SIB 64 01 26

RECALL 26V-096: CHECK AND REROUTE COCKPIT WIRING HARNESS

2026-03-12

This Service Information Bulletin (Revision 4) replaces SI B64 01 26 **dated March 2026**.

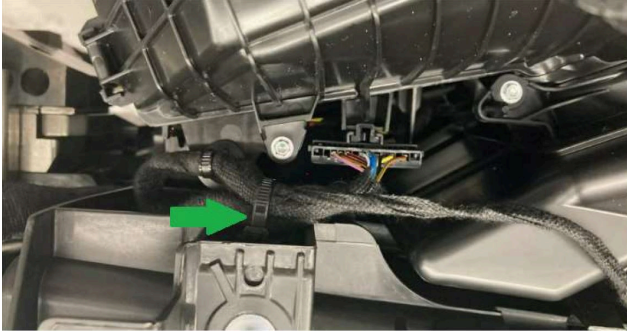
When servicing the cabin air microparticle nanofilter, it is possible to pinch and thereby damage the vehicle's wiring harness while re-installing the retaining screws for the cabin air nanofilter's plastic cover.

Inspect the harness routing, and add a retainer to the harness (arrow) to prevent it being pinched under the air filter plastic cover.

Use caution when re-installing the plastic cover for the cabin air filter to ensure no damage is done to the vehicle's wiring harness.

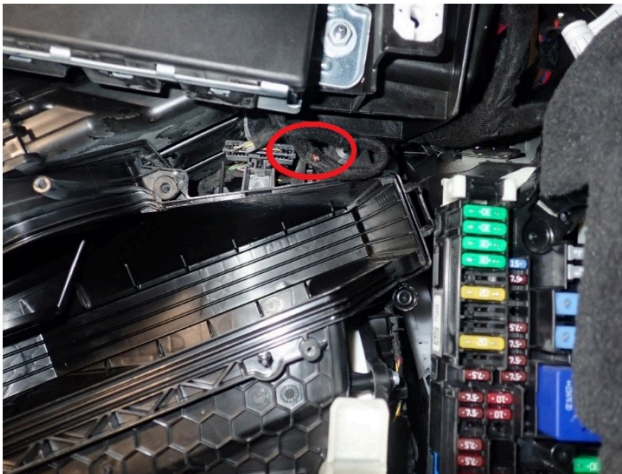
Check the vehicle wiring harness routing (circled) to ensure it is not pinched by the plastic cover over the filter.

This is where the harness can be damaged when installing the cabin air filter cover screw.

This shows the harness damage; the sheathing has been abraded.

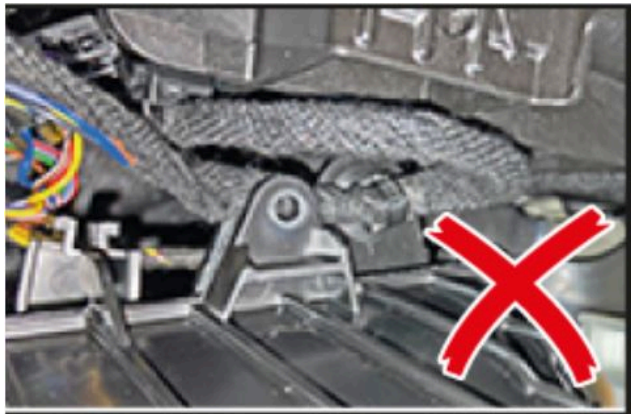
With the harness pulled out of the way, you can see the screw mounting hole for the cabin air filter cover.

The upper photo has the harness visible through the mounting hole. This positioning is not acceptable- the harness must be moved out of the way of the mounting screw.

The lower photo shows the harness positioned in front of the mounting screw, which is an acceptable routing.

Double check the routing of the harness prior to installing the screws for the cabin air filter cover.

If the wiring harness has already been damaged during the installation of the cabin air filter cover, the damaged section of the wiring harness must be repaired.

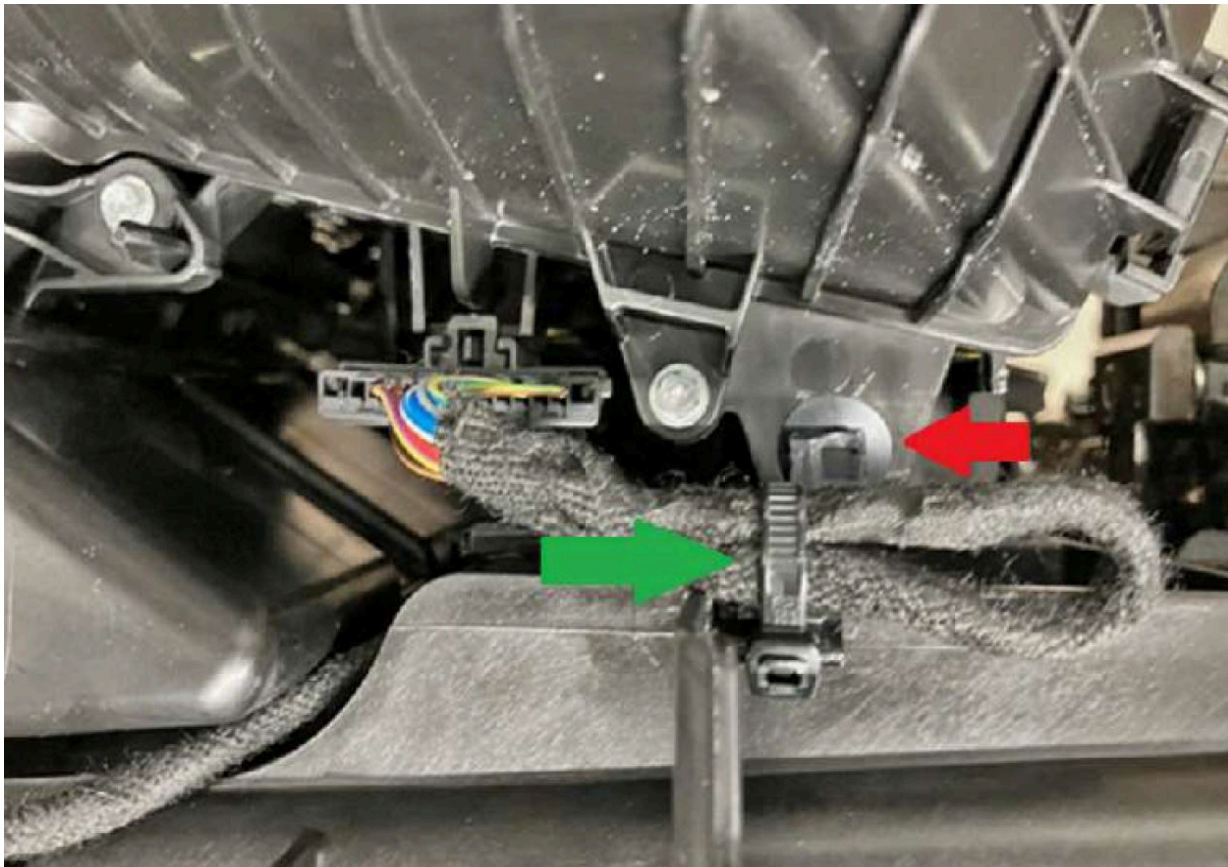
The original harness retainer must be disconnected. This is shown by the red arrow below. It can be left clipped into vehicle but must be disconnected from harness for strain relief.

Install a new harness retainer with cable strap on the instrument panel wiring harness, see green arrow.
